US 27/SR 1 - HAMILTON ROAD WIDENING
Project No. NH-017-1(20)
P.I. No. 322250
Troup County

Value Engineering Study Report
Preliminary Design Submittal

December 2007

A-4

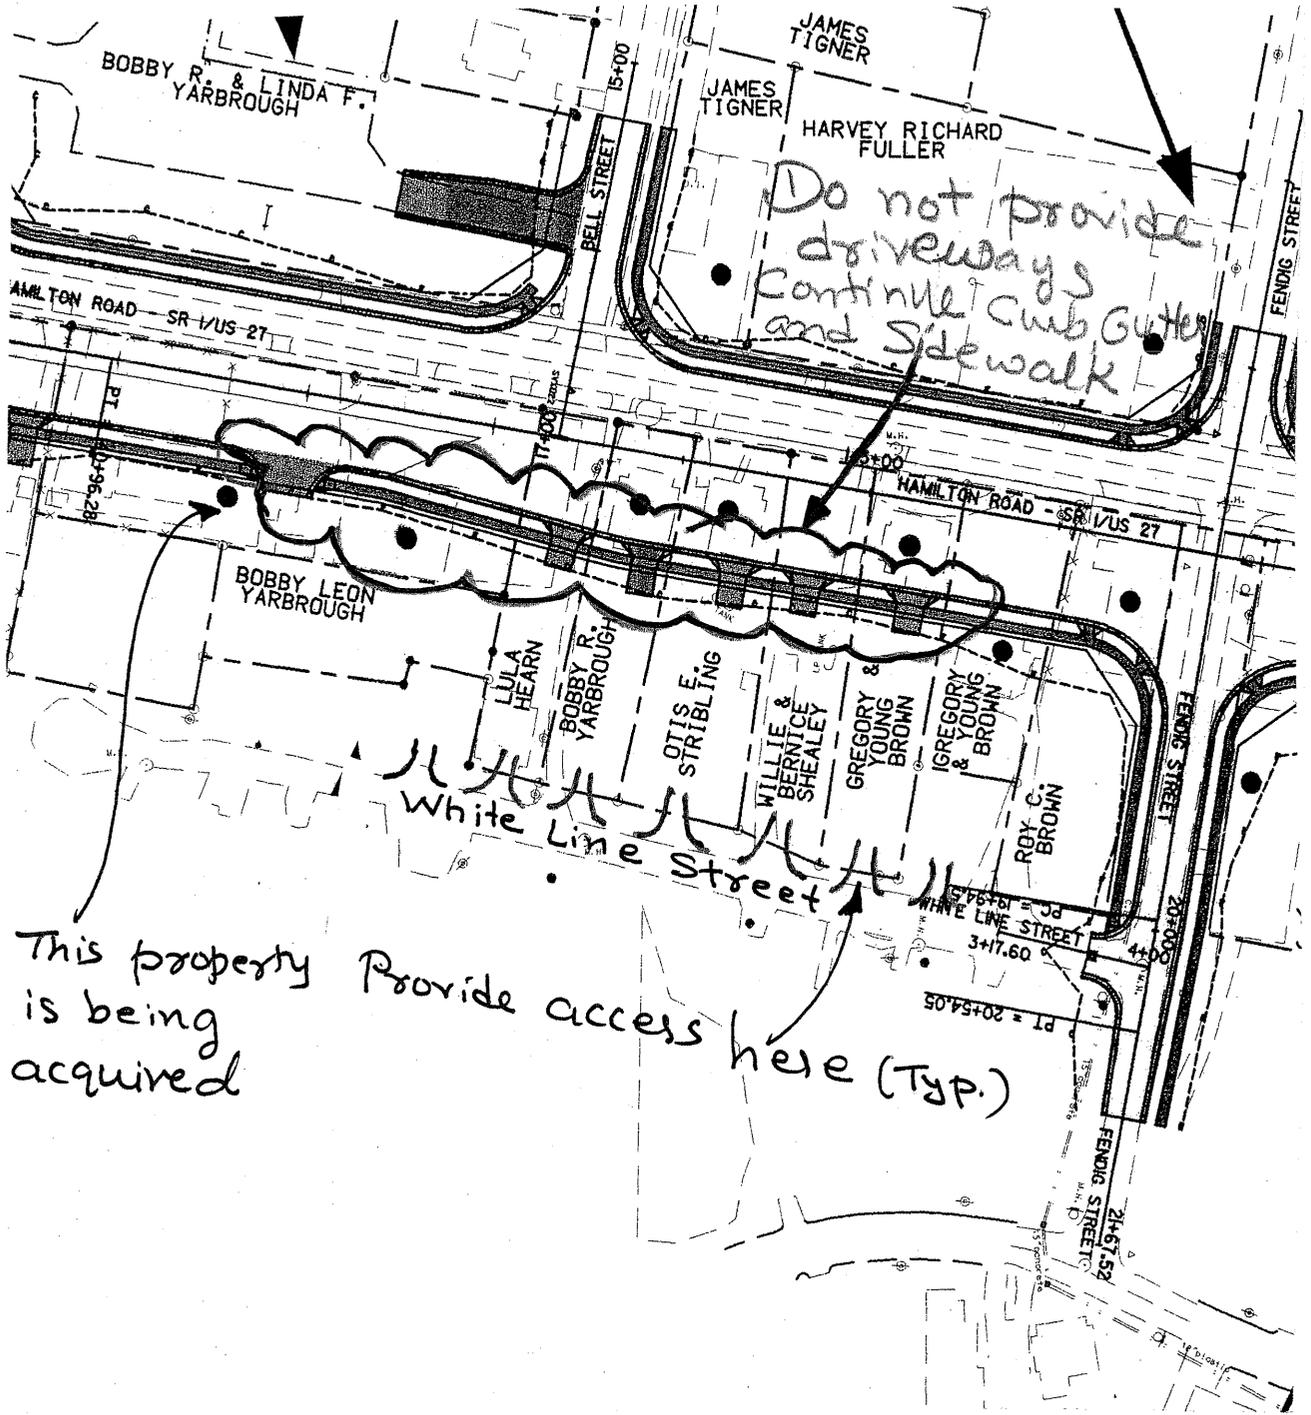
Close off these driveways and provide access to these five properties from the back on White Line Street.

Access to five properties from White Line Street already exists. Bob's Paint and Body Shop will be acquired. There is no reason to provide/update a driveway. In the future, this property can still be accessed from White Line Street.

ALTERNATIVE NO.:
A-7

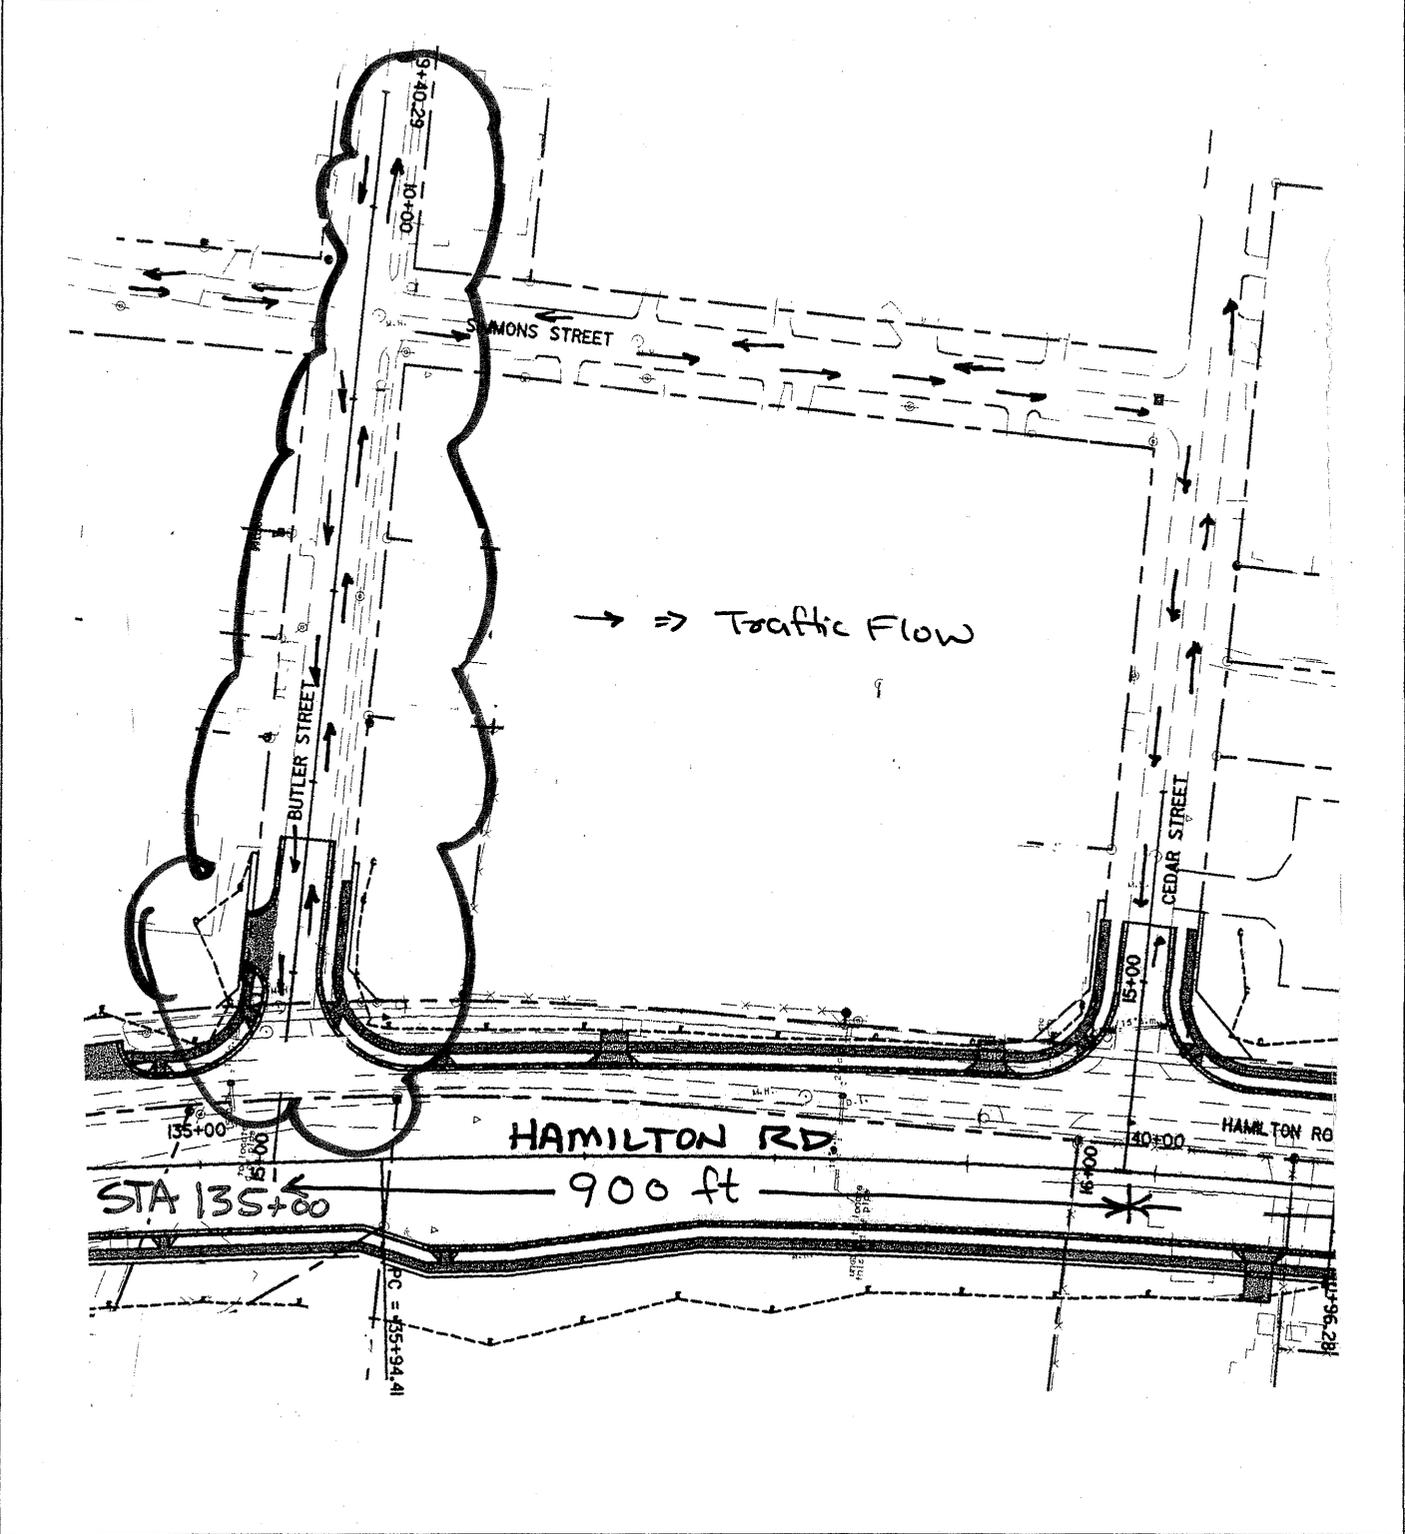
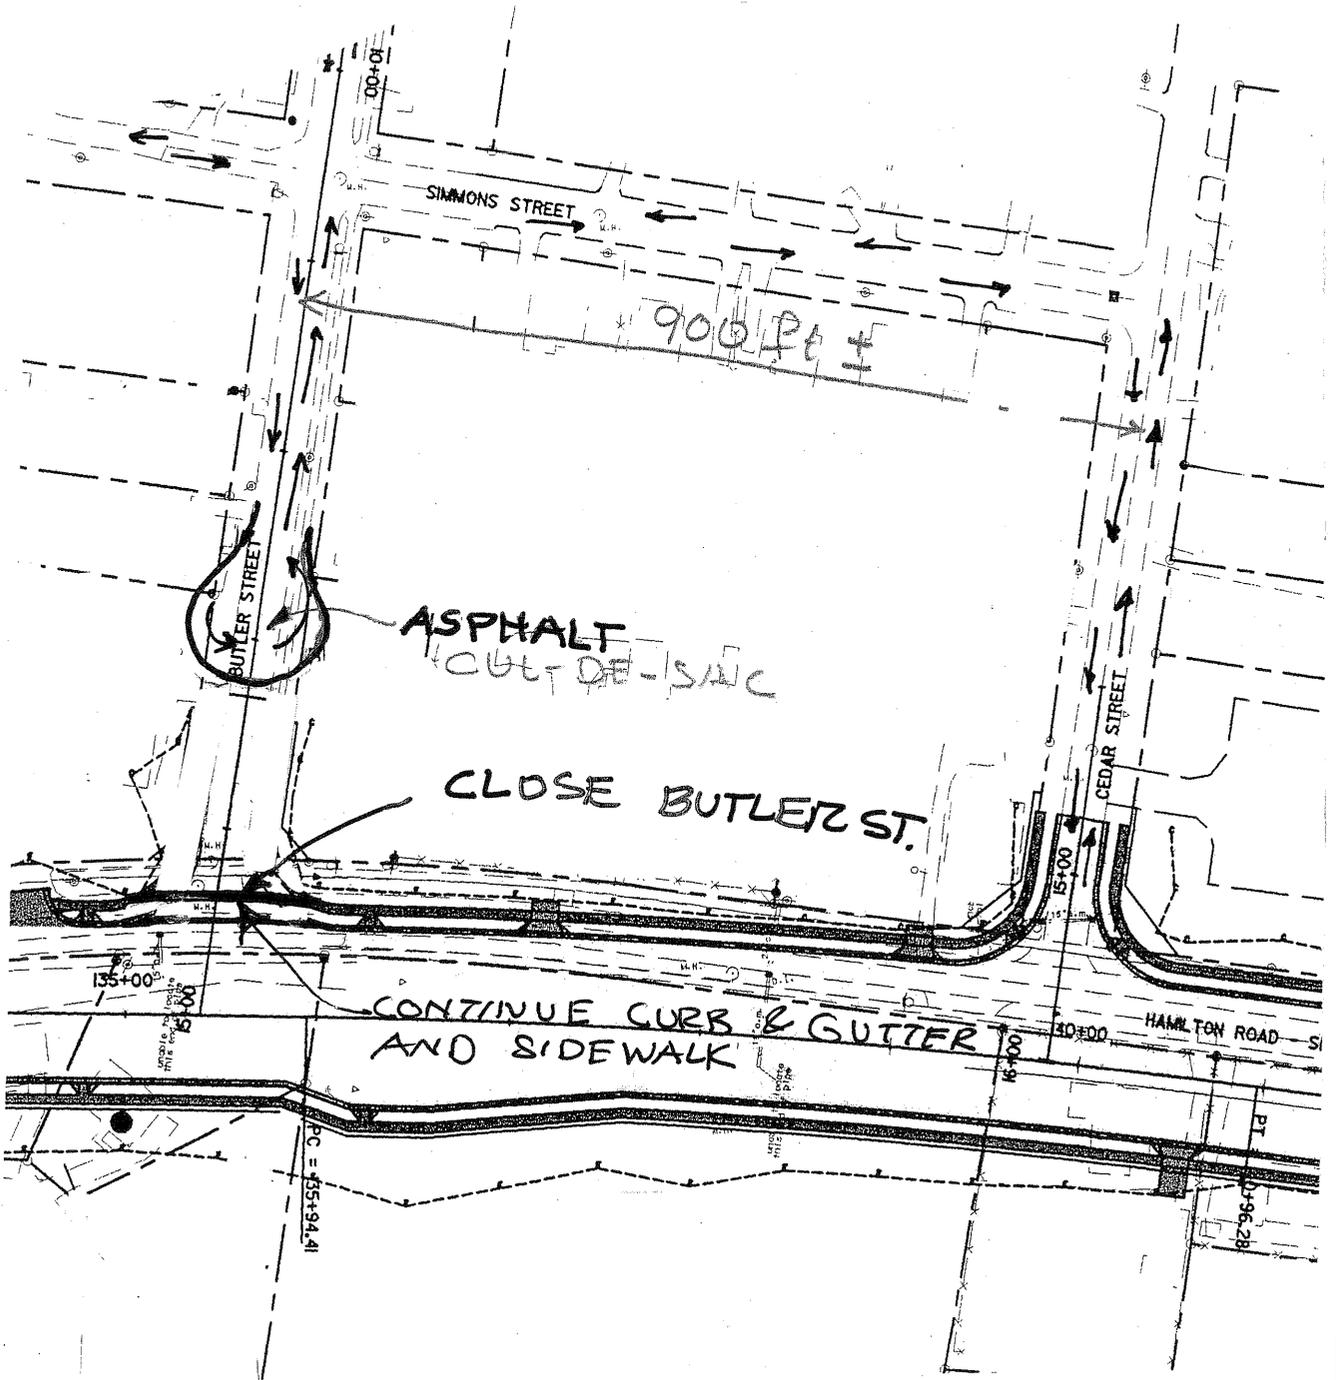
Close the Butler Street access to Hamilton Road and provide a cul-de-sac.

The cost to provide a cul-de-sac will be offset by savings resulting from not having to provide improvements as proposed on Bell Street. Drivers wanting to turn south on Hamilton from Butler will have to drive only 1,800 ft. ± than ½ mile.

ALTERNATIVE NO.:
A-8

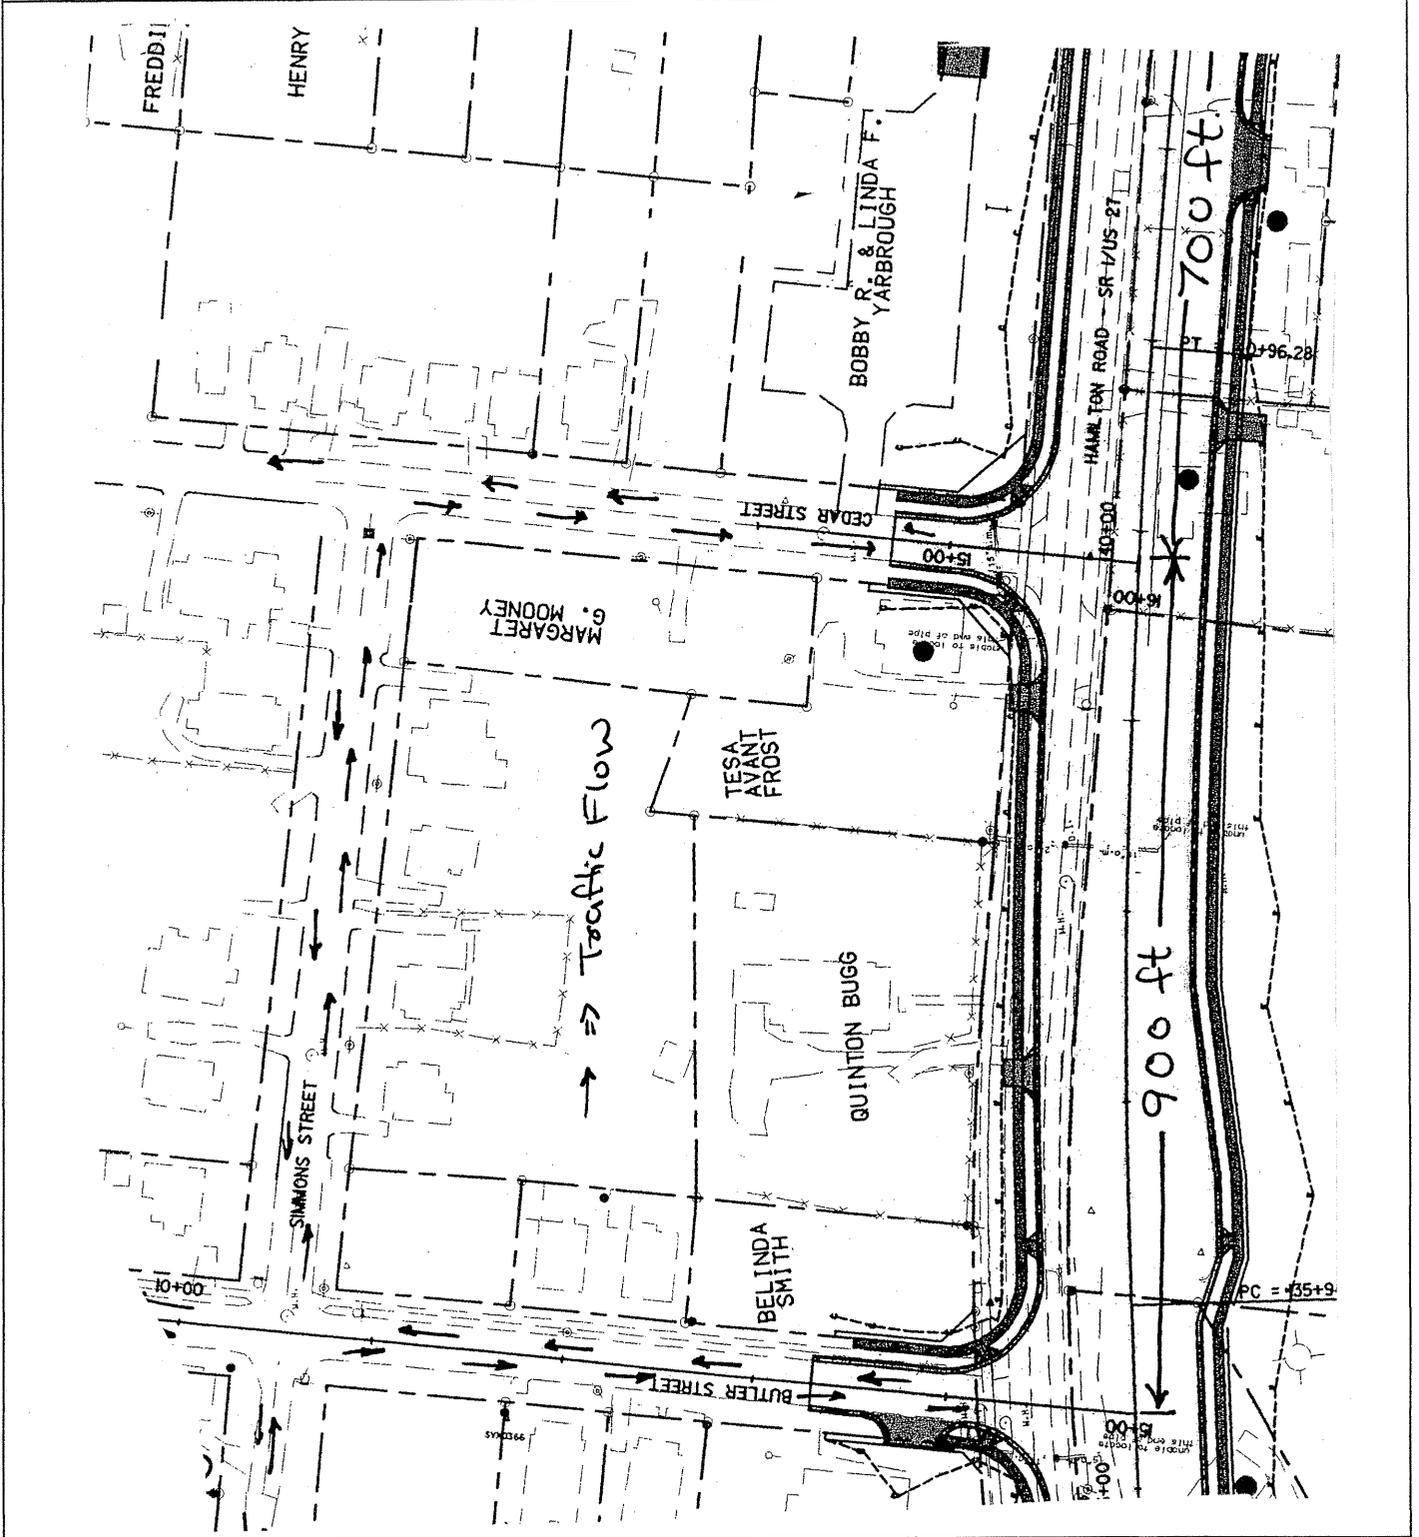
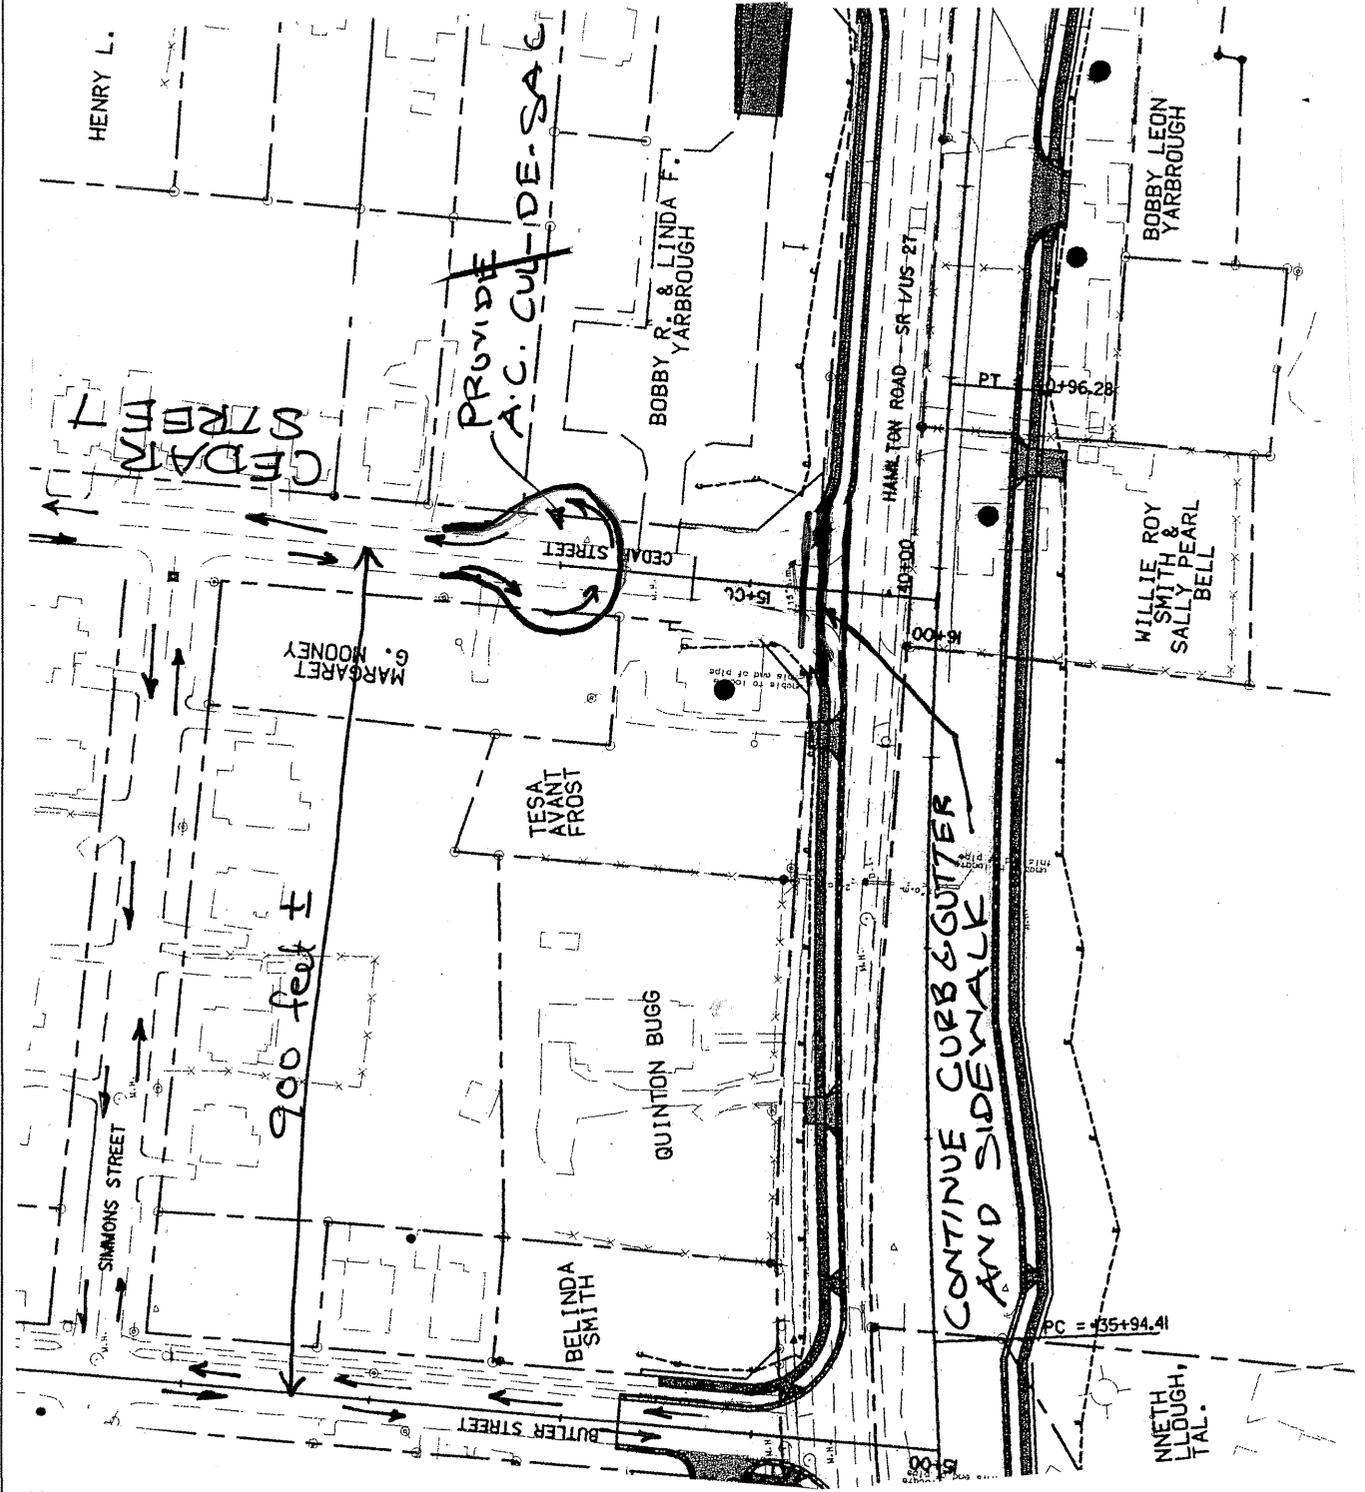
Close Cedar Street's connection to Hamilton Road and provide a cul-de-sac.

The cost to provide a cul-de-sac will be offset by savings resulting from not having to provide improvements as proposed on Cedar Street. The costs to continue curb, gutter and sidewalk would be insignificant.

Drivers wanting to turn north on Hamilton Road from Cedar Street will have to proceed about 1,800 ft.±, which is less than ½ mile.
